# MEMO

**To:** Kristopher Byrd, Well Construction and Compliance Section Manager  
**From:** Travis Kelly, Well Construction Program Coordinator  
**Subject:** Review of Water Right Application LL-1811  
**Date:** July 17, 2020

Application # LL- 1811

PUBLIC INTEREST REVIEW FOR GROUNDWATER APPLICATIONS

WELL SEAL FOR  
PAUL RUDD

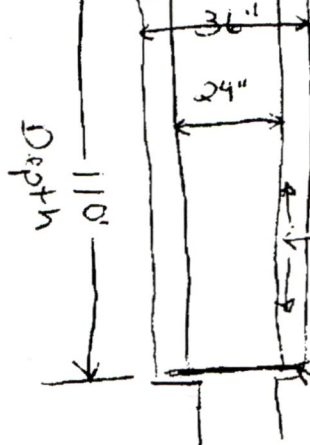
Applicant's Well #1 (UNIO 51835(Original Well Report)/UNIO 51770(Alteration Well Report)):  
Based on a review of the Well Reports, Applicant's Well #1 seems to protect the groundwater resource.

The construction of Applicant's Well #1 may not satisfy hydraulic connection issues.

Water-Level Trends in Nearby Wells

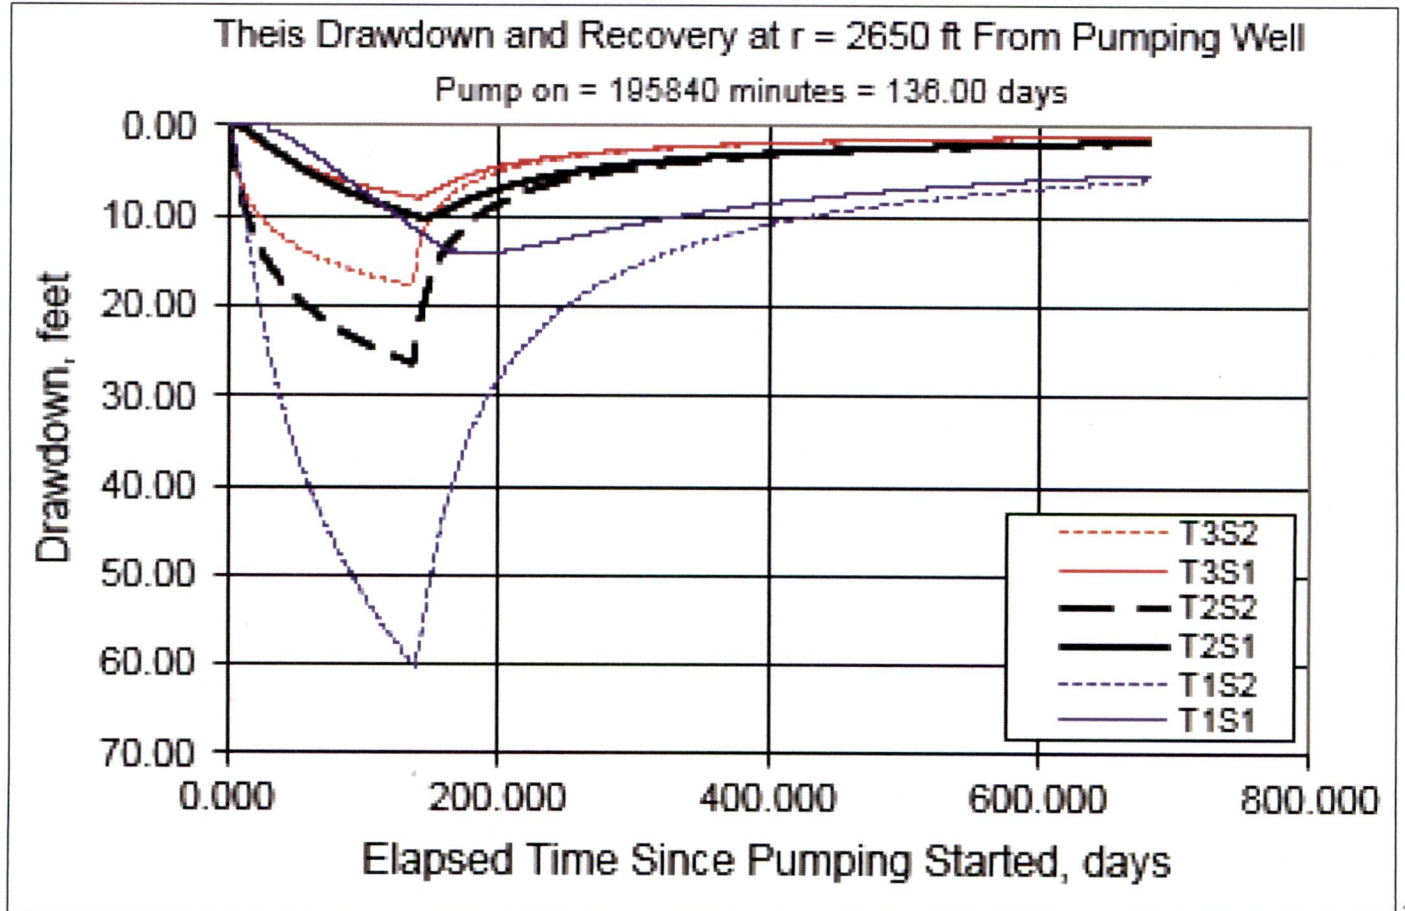
Observation well data from nearby alluvial wells is quite limited, but basin-wide trends do not display significant declines in the alluvial system.
